Access Compliance Report

Public Rights-of-Way

Intersection ID: 46786	Main Street: MILLSTREAM RIDGE DR	Cross Street: AUTUMN HARVEST LN	Location: NE
ADA ID: A996D28778A5	Ramp Type: PerpDiag	Initial Pass/Fail: Fail	Overall Compliance: No
Severity Score: 37.5			
Codes/Mitigation Info/Possible Solution		Field Measurements/Component Compliance

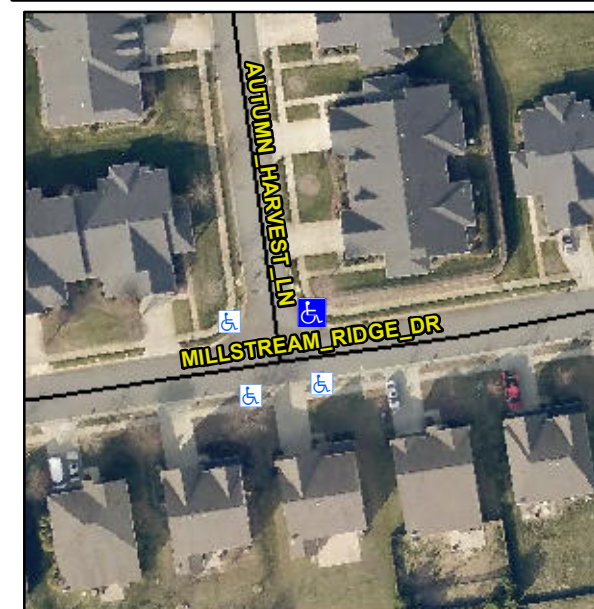
Not Found, R304.2.2, R304.5.3

Compliance	Description	Data	Compliance	Description	Data
N/A	Ramp Length (in)	47.0	No	Ramp Slope (%)	8.7
Yes	Ramp Width (in)	48.0	No	Ramp XSlope (%)	7.3
N/A	Flare Type LT	N/A	N/A	Flare Type RT	N/A
N/A	Flare Slope LT (%)	N/A	N/A	Flare Slope RT (%)	N/A
N/A	Flare Traversable LT?	N/A	N/A	Flare Traversable RT?	N/A
N/A	Landing Length (in)	N/A	N/A	DWS Provided?	N/A
N/A	Landing Width (in)	N/A	N/A	DWS Contrast?	N/A
N/A	Landing Slope (%)	N/A	N/A	DWS Length (in)	N/A
N/A	Landing X Slope (%)	N/A	N/A	DWS Full Width?	N/A
N/A	Landing Curb? (Y/N)	N/A	N/A	DWS Offset (in)	N/A
N/A	Shared Landing?	N/A			
N/A	Gutter Ponding?	N/A	N/A	Gutter Slope (%)	N/A
N/A	Gutter Lip Ht (in)	N/A	N/A	Gutter X Slope (%)	N/A
N/A	Painted X Walk1?	No	N/A	Painted X Walk2?	No
	X Walk 1 Direction	To W		X Walk 2 Direction	To S
N/A	X Walk 1 Width (in)	N/A	N/A	X Walk 2 Width (in)	N/A
	X Walk 1 Slope (%)	2.7		X Walk 2 Slope (%)	5.8
	X Walk 1 X Slope (%)	6.1		X Walk 2 X Slope (%)	3.1

N/A	Ramp inside XWalk1?	N/A	N/A	Ramp inside XWalk2?	N/A
	Road Slope (%)	6.6	N/A	Clear Space?	N/A
	Road X Slope (%)	3.2	N/A	Clear Space to XWalk (in)	N/A
N/A	Any Obstructions?	N/A	N/A	Storm Grate/Utility Hazard?	N/A
	Obstruction Type			Storm Grate/Utility Type	
		N/A			N/A
			Yes	Surface Condition? (G/P)	Good

Remove & Replace Curb Ramp With Two New Directional Ramps or Equivalent.
